City and Borough of Juneau
Engineering Department
155 South Seward Street
Juneau, Alaska 99801
Telephone: 586-0490 FAX: 586-0897

ERRATA SHEET 1

THE CITY AND BOROUGH OF JUNEAU PUBLICATION August 2011 of the STANDARD DETAILS

ERRATA DATE: October 26, 2015

| APPROVED BY: <i>JB</i> | 8-28-15 | REVISED: August 2015 | STANDARD 304A |

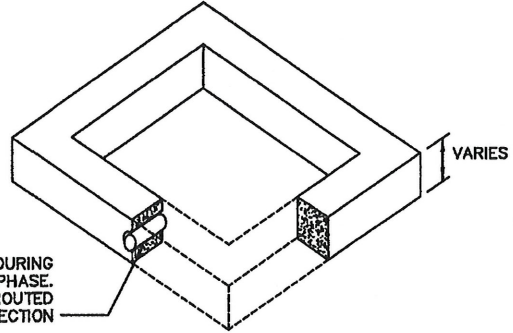
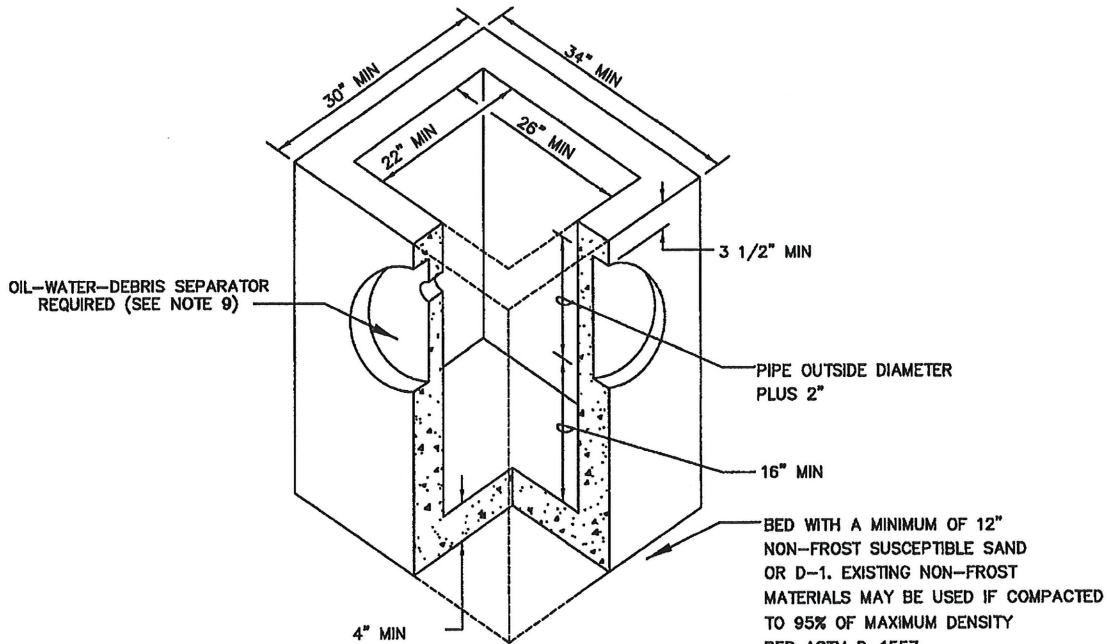
| Item No. | Standard No. | Standard Name | Correction |
|----------|--------------|--|---|
| 1 | 304A | Type III Catch Basin | <i>Delete</i> in its entirety and <i>replace</i> with Standard 304A, dated August 2015. |

| APPROVED BY: <i>JS 8-28-15</i> | REVISED: 8/12/2015 | STANDARD 407 | |

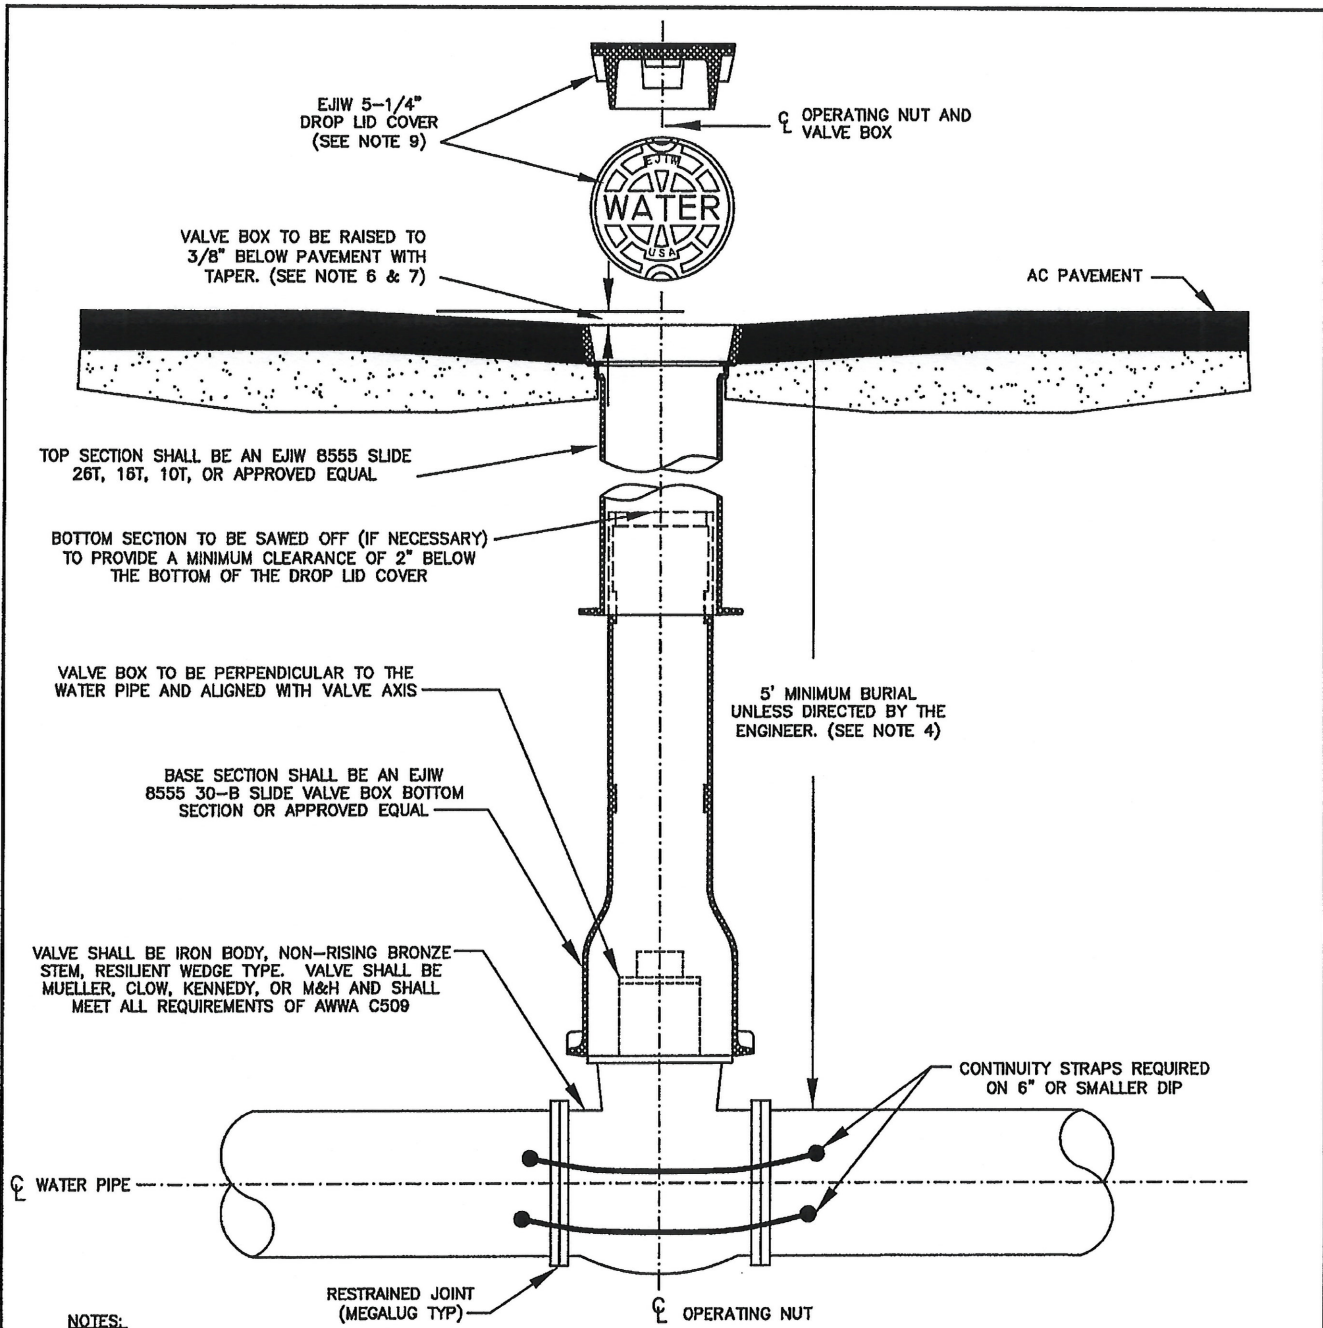
| Item No. | Standard No. | Standard Name | Correction |
|----------|--------------|--|---|
| 2 | 407 | Mainline Valve | <i>Delete</i> in its entirety and <i>replace</i> with Standard 407, dated August 12, 2015 |

| APPROVED BY: <i>[Signature]</i> 8-28-15 | | REVISED: 8/28/2015 | | STANDARD 419 | |

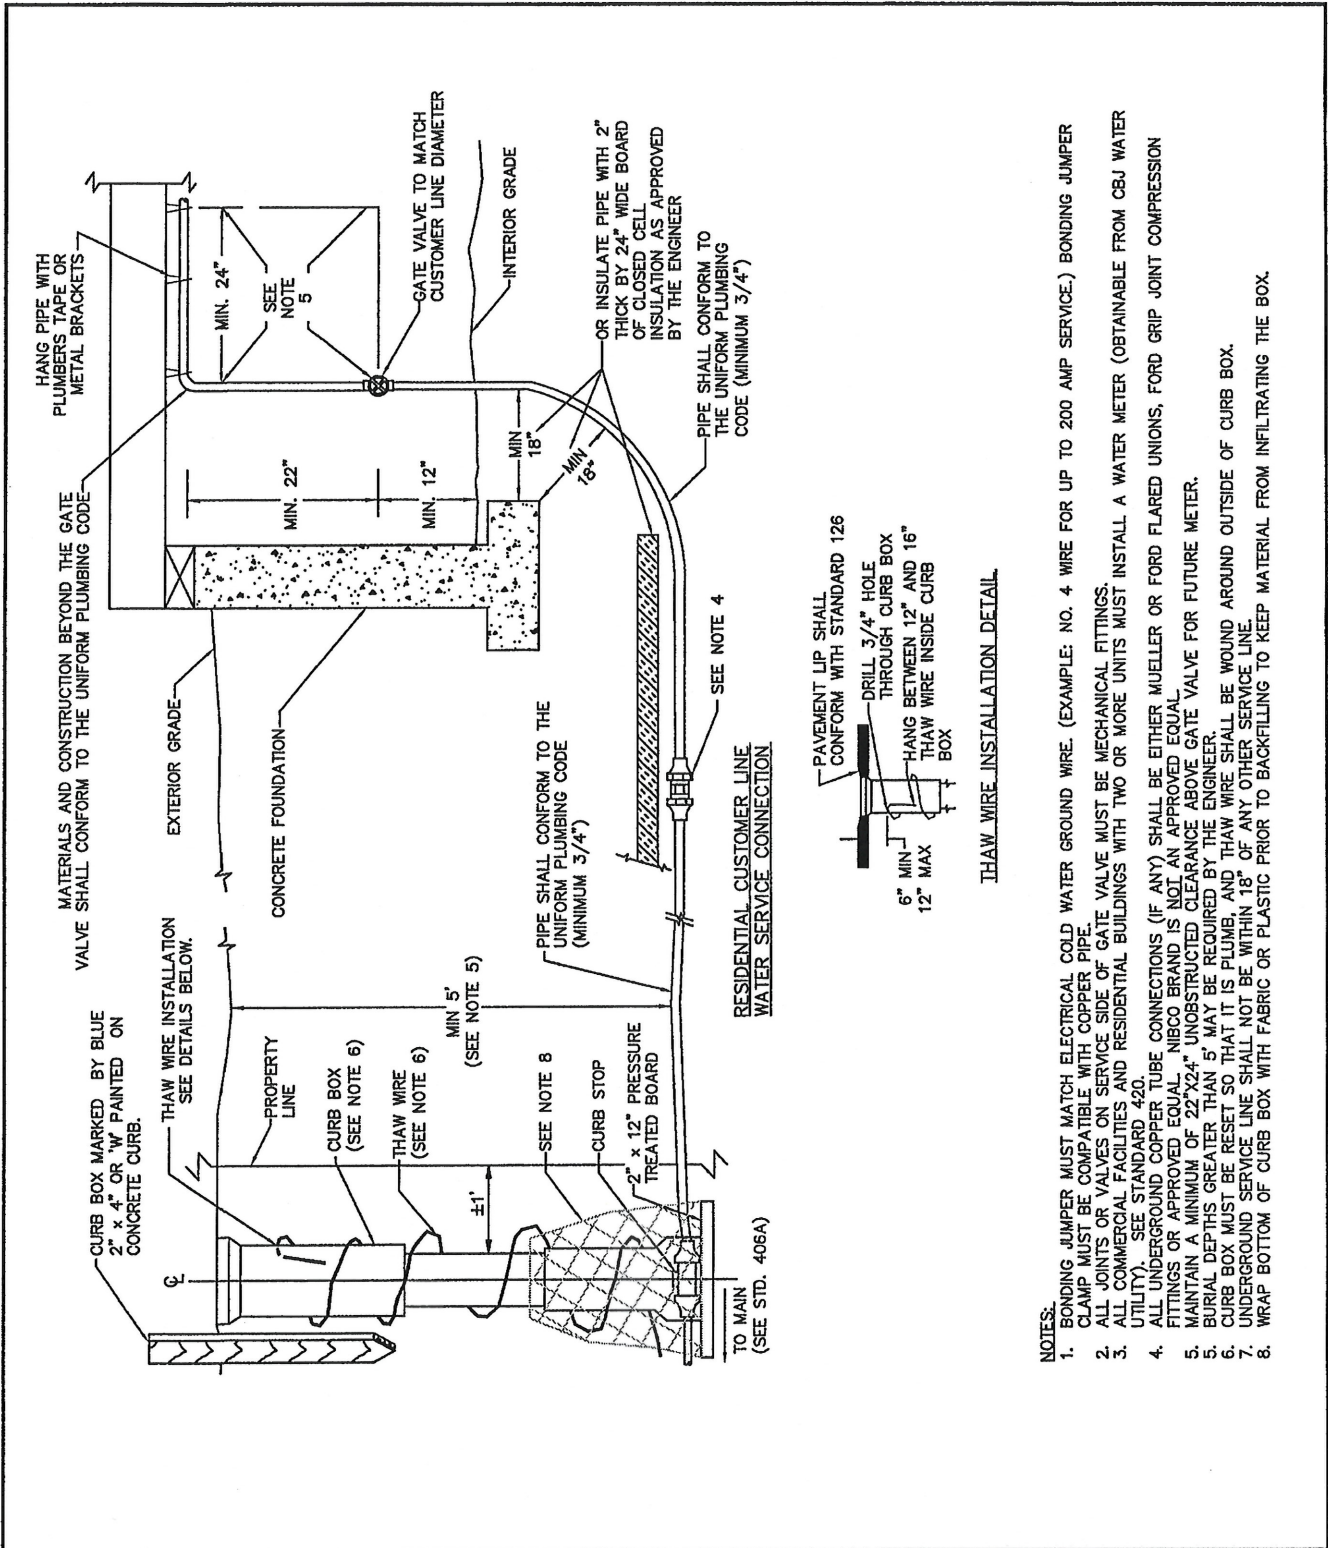
| Item No. | Standard No. | Standard Name | Correction |
|----------|--------------|--|---|
| 3 | 419 | Residential Customer Line Water Service Connection | <i>Delete</i> in its entirety and <i>replace</i> with Standard 419, dated August 28, 2015 |

| APPROVED BY: | REVISED: Sept 2015 | STANDARD 105 | |

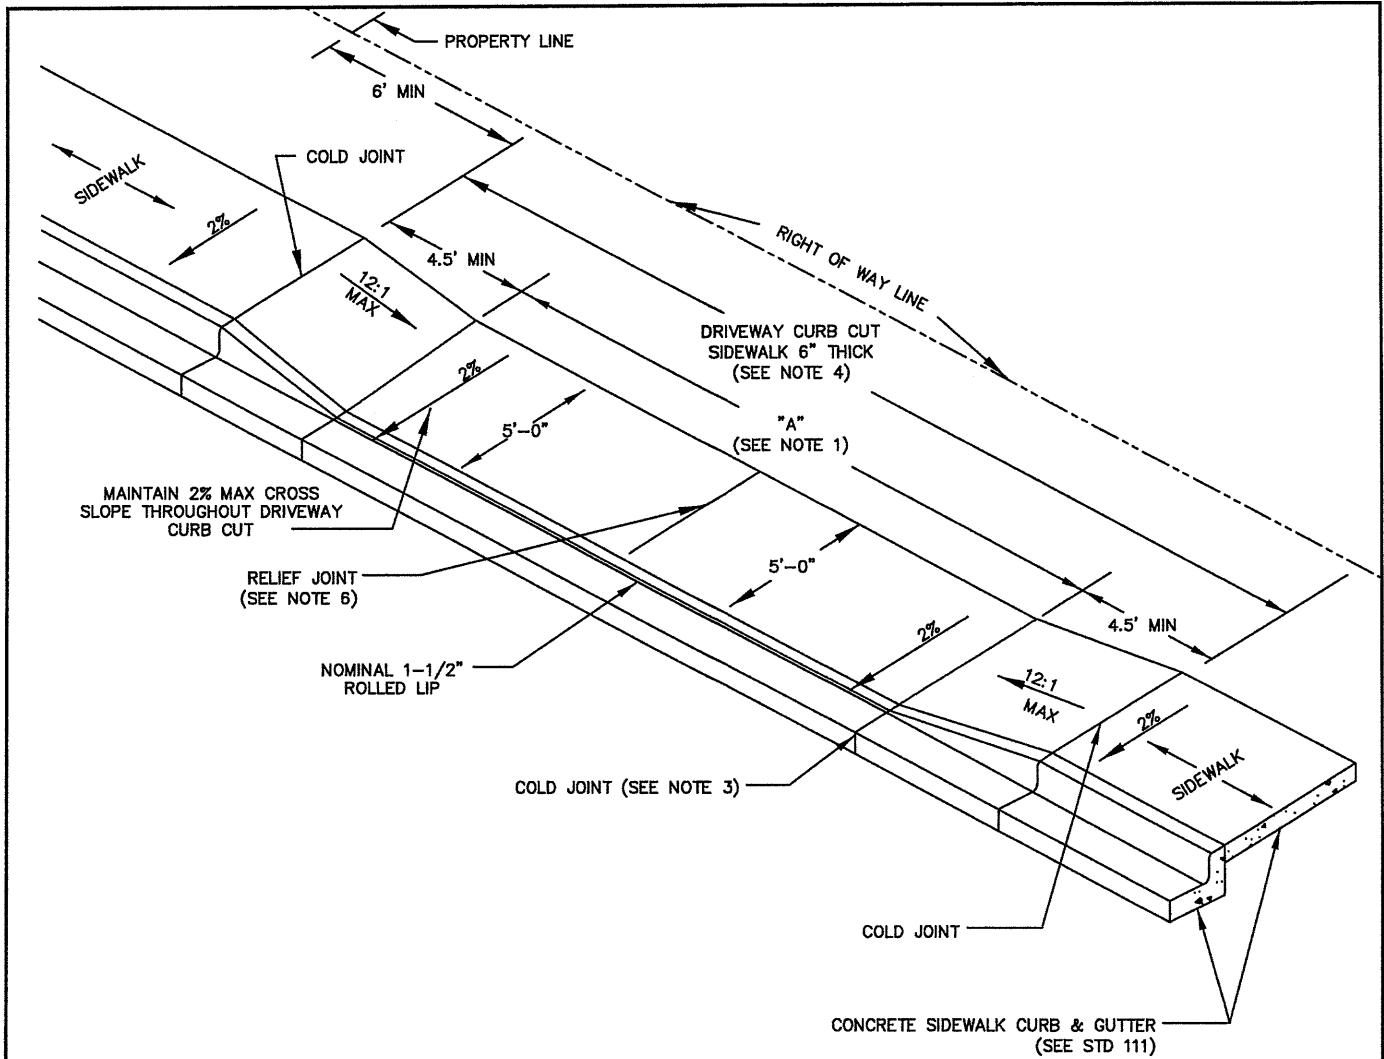
| Item No. | Standard No. | Standard Name | Correction |
|-----------------|---------------------|----------------------|---|
| 1 | 105 | Driveway Curb Cut | <i>Delete</i> in its entirety and <i>replace</i> with Standard 105, dated September 2015. |
